**SR-2 – ADVISORY STAFF REPORT (03-06-2026)**

**ADDRESS:** 1616 CHICAGO

**APPLICATION NUMBER:** HDC2025-00753

**SCOPE:** DEMOLISH GARAGE (WORK COMPLETED), DEMOLISH REAR WING (WORK COMPLETED), REHABILITATE HOUSE

**Rear wall prior to unapproved work. Yellow arrow indicates that former, two-story sunporch which was recently removed without HDC approval. Note wood windows and decorative rafter tails at roof eaves, the massing and form of the wing, and the overall building footprint. Photo by applicant**

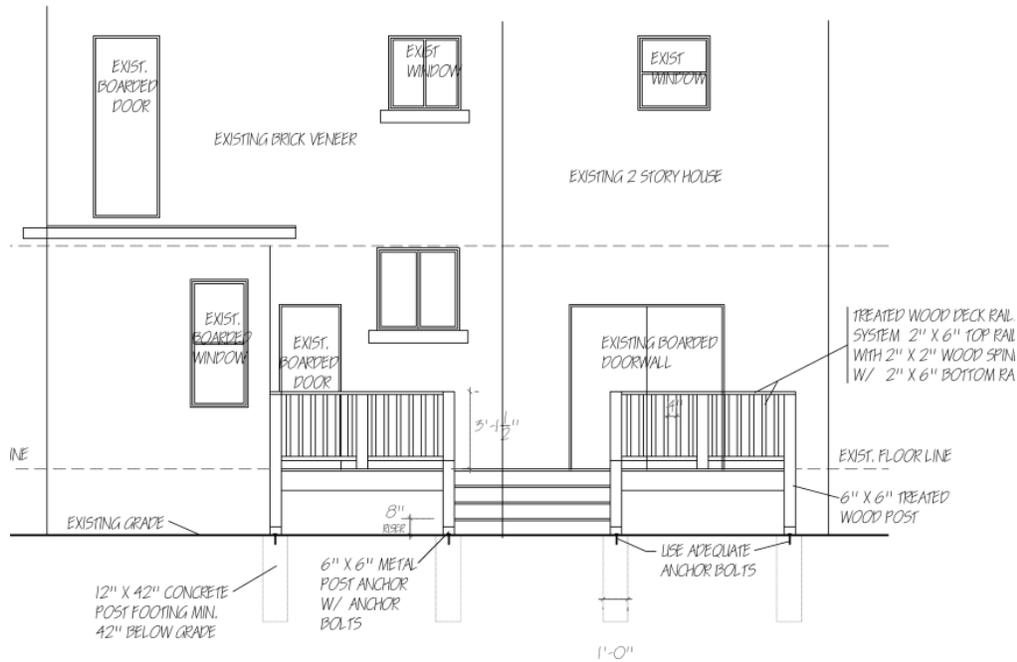
- The wing that was removed without HDC approval was two-stories in height and was clad with stucco. Windows at the first story were historic wood casement units with wood transoms while the second story windows were wood casement units. Consistent with the house's main roof, the eaves at the wing's flat roof displayed decorative rafter tails. The doors were the historic wood French doors. Also, the projection and massing of the original wing is lost in the truncated replacement. It is staff's opinion that this wing was a distinctive, historic character-defining feature of the building.

- Therefore, per the Standards, the wing should have been retained and repaired using in-kind materials. If repair was not possible, then the wing should have been rebuilt to match the original. The current application does not meet the Standards because it proposes not to rebuild the wing which was demolished without HDC approval.

- Furthermore, the application is seeking to retain the vinyl siding and vinyl window that was installed at the rear wall/the location of the former wing without HDC approval. These work items do not conform to the Elements of Design for the district because, as noted above, most houses are clad with brick and/or stucco and windows are typically made of wood. Also, vinyl siding does not adequately reproduce a historic wall surface and the proposed/extant vinyl window at this location does not mimic the dimensionality, texture, and finish of historic window sash.

**Proposed rear wall and deck (elevation), by applicant**

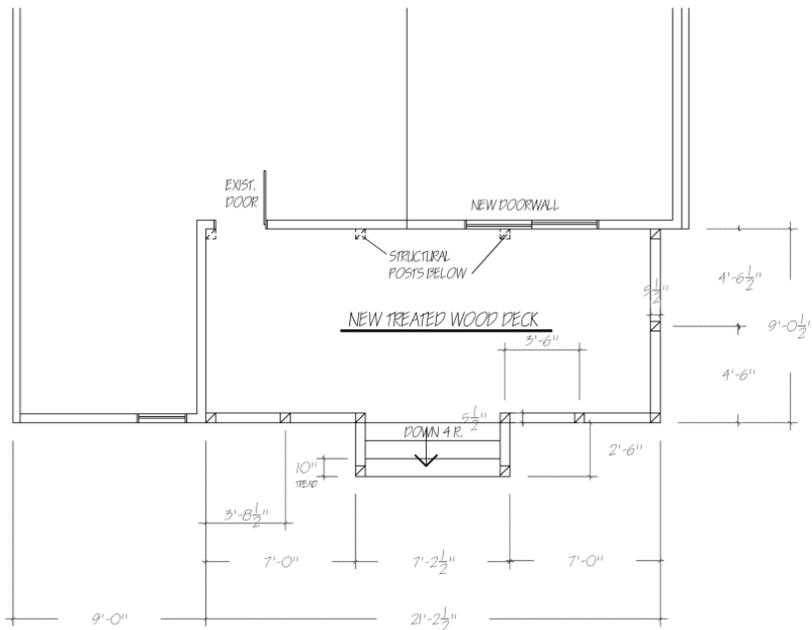
2. While the design of the new rear deck appears to be compatible with the building's historic character, its location is not appropriate because it is proposed to be erected within the footprint of the former two-story sunroom wing that was demolished without HDC approval.

- Finally, while the design of the new rear yard deck would not detract from the building's historic appearance, staff does not recommend approval of this scope item as proposed because it will be erected within the footprint of the former rear two-story sunroom wing that was removed without HDC approval.

1. The proposed rear deck shall not extend into the footprint of the former two-story rear sunroom wing. The new design shall be submitted to staff prior to the issuance of the permit for review and approval.

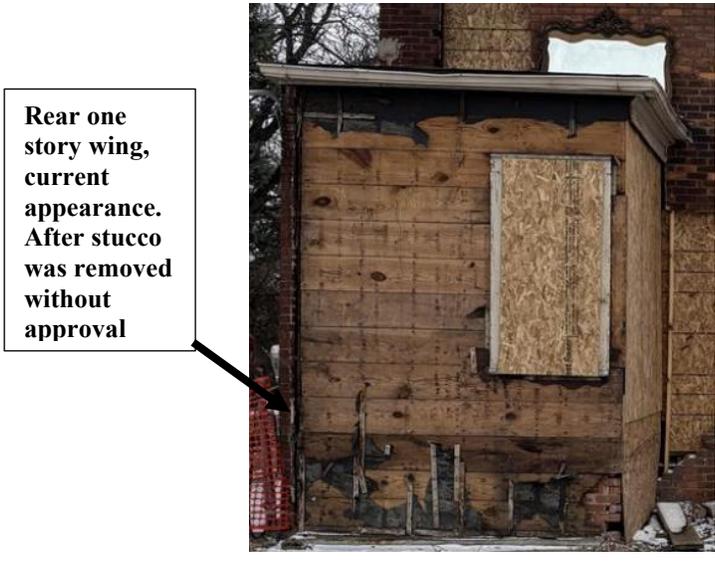
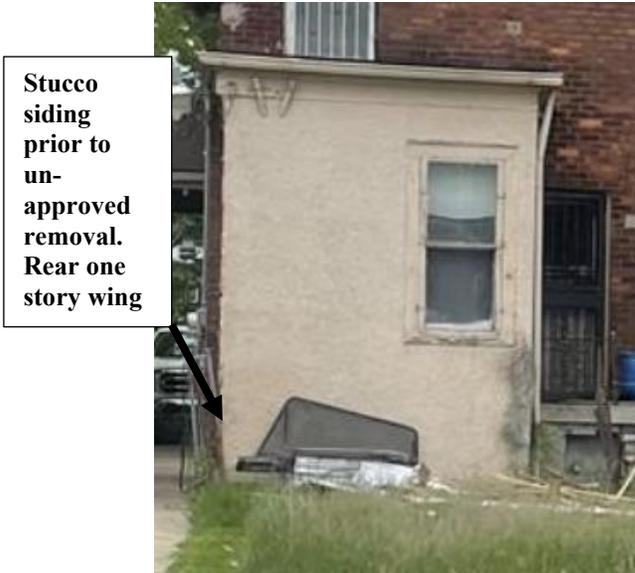
- The stucco cladding that was at the rear, one-story wing’s side and rear walls was historic and was consistent with the stucco cladding that was at the former rear, two-story wing (see the below images). The siding was a distinctive finish that characterized the property and conformed to above-listed Element of Design #7, which notes that stucco is commonly found within the district. The proposed replacement of the siding with lapped wood siding does not conform to the

Standards, which require that the replacement siding match the original. Also, Element of Design #7 states that wood "...clapboard is rare" within the district. Staff therefore recommends against the approval of this work item.

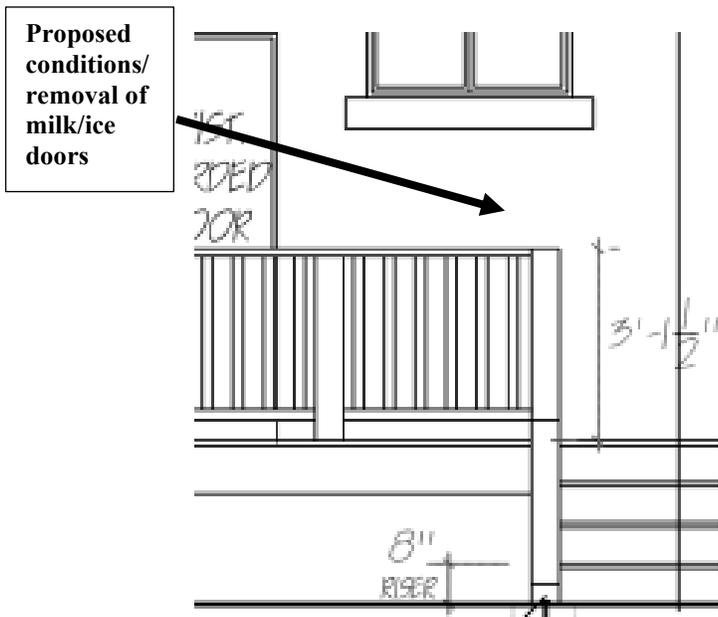
- See the below images. The rear elevation drawing which was submitted with the application indicates that the existing milk/ice doors and the stone sill beneath at the rear wall, first story will be removed and the opening infilled (material not specified). These elements date from the period of significance and speak to the house's appearance prior to the development of widespread/modern refrigeration. The proposed removal of such a feature that characterizes the property does not meet the Standards. Staff therefore recommends against its removal.
